**SUBJECT: Chassis Exhaust Wraps For
Some Crosswind J T4i, J T4F,
and JS units**

DATE: 04/01/2019
NUMBER: SB-0217-C

- Certain Crosswind J T4i, J T4F, and JS sweepers mounted on Freightliner M2 chassis require the chassis engine exhaust pipe to be covered with an insulating wrap. There are three different FSO kits for different groups of sweepers. This bulletin updates the prior SB-0217 bulletin. Sweepers that have had the 1129387 FSO kit installed will need to be updated with the new FSO kit 1131756.

FIGURE 2 - 1128118 WRAP, FORWARD

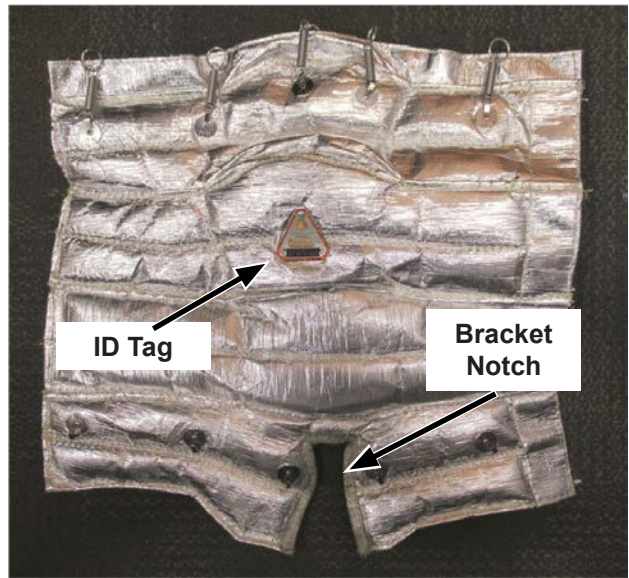
4. If a 1128118 wrap was installed on a unit that now requires FSO kit 1131756, the 1128118 wrap must be removed and discarded. FSO 1131756 must be installed.
5. Follow the instructions on the FSO Kit drawings. Contact FS Depot if you did not receive the drawing with the parts. The instructions are summarized here.
6. Look for accumulated debris under the cab. If there is debris, show the customer what has accumulated and instruct them to follow maintenance instructions in manuals provided to them, including thorough cleaning and washdowns on a daily basis.

FIGURE 1 - 1131546 WRAP, FORWARD LONG

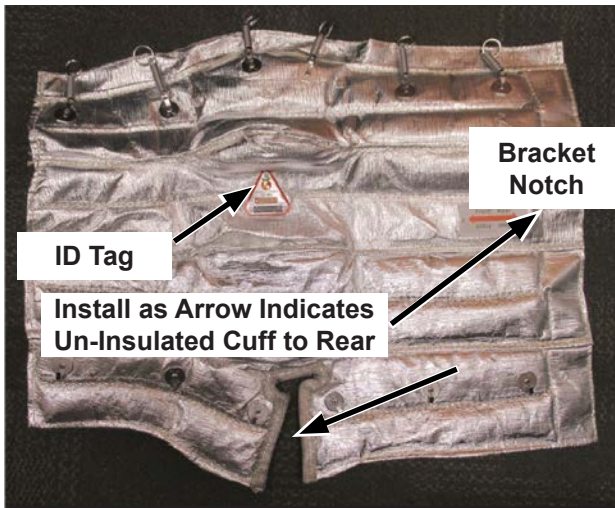
- All affected sweepers must have the insulation wraps properly installed. The new 1131756 FSO kit replaces the 1129387 FSO kit and is effective for the same group of sweepers as listed on page 6. FSO kits 1129623 and 1129619 are effective for the sweeper groups listed on pages 7 and 8 respectively.

FIGURE 7- Top View, P/N 1131546 Wrap Forward Long

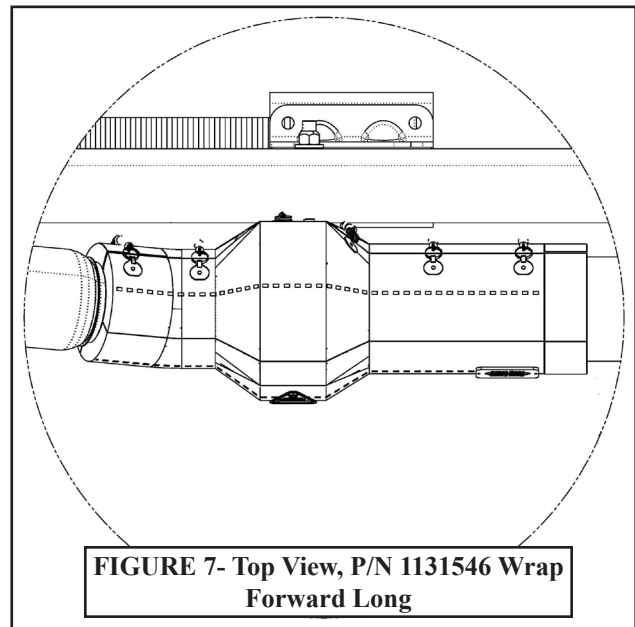
1. For units with Allison RDS 2500 transmissions, access to the chassis engine exhaust may be easier from the left side over the top of the transmission.
2. For units with Allison RDS 3500 transmissions, access to the chassis engine exhaust may be easier from the bottom and right side.
3. See P/N 1131546, FIGURES 4, 5, 6, and 7. See P/N1128118, FIGURES 4, 8 and 9.
4. The 2" un-insulated cuff must be to the rear. FIGURES 1 and 5
5. Start with the silver side down and slide the wrap under the exhaust pipe from the inboard side.
6. Slide the support bracket notch in the wrap around the bracket.
7. Wrap the insulation tightly around the exhaust pipe with the springs to the top.
8. Hook the springs to the corresponding hooks.

1. The 2" un-insulated cuff must be to the rear of the front wrap.
2. The 1" un-insulated edge must overlap on top of the insulated edge.
3. All springs must be hooked.
4. The part number ID tag and installation aid tag should be at the 9 o'clock index position when looking from the rear of the pipe. See Figures 5 and 6 for the P/N11311546 installation and Figure 9 for the P/N1128118 installation.
5. No chassis exhaust pipe surface can be exposed along the length of the wrap.
6. No chassis exhaust pipe surface can be exposed at the rear of the front wrap.

FIGURE 10- Top View, P/N 1129213 Wrap, Mid

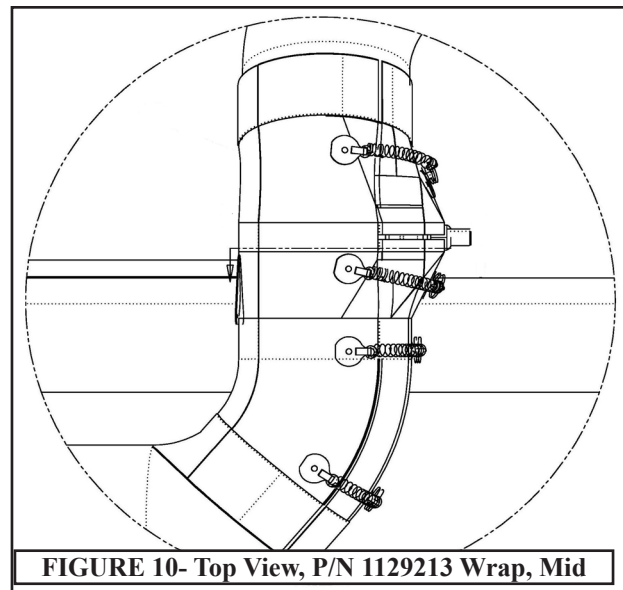
1. See FIGURES 10 and 11.
2. With the silver side down, slide the wrap under the pipe from the front.
3. Slide the support bracket notch around the bracket.
4. Wrap the insulation tightly around the exhaust pipe with the springs to the rear.
5. Hook the springs, two inboard, two outboard.
6. All springs must be hooked.

1. The 2.0" un-insulated cuff must be inboard.
2. The 1.0" un-insulated cuff must be outboard.
3. The wrap must be located so that the springs are arranged with two inboard and two outboard.
4. All springs must be hooked.
5. There can be no exposed exhaust pipe after the wrap is installed.
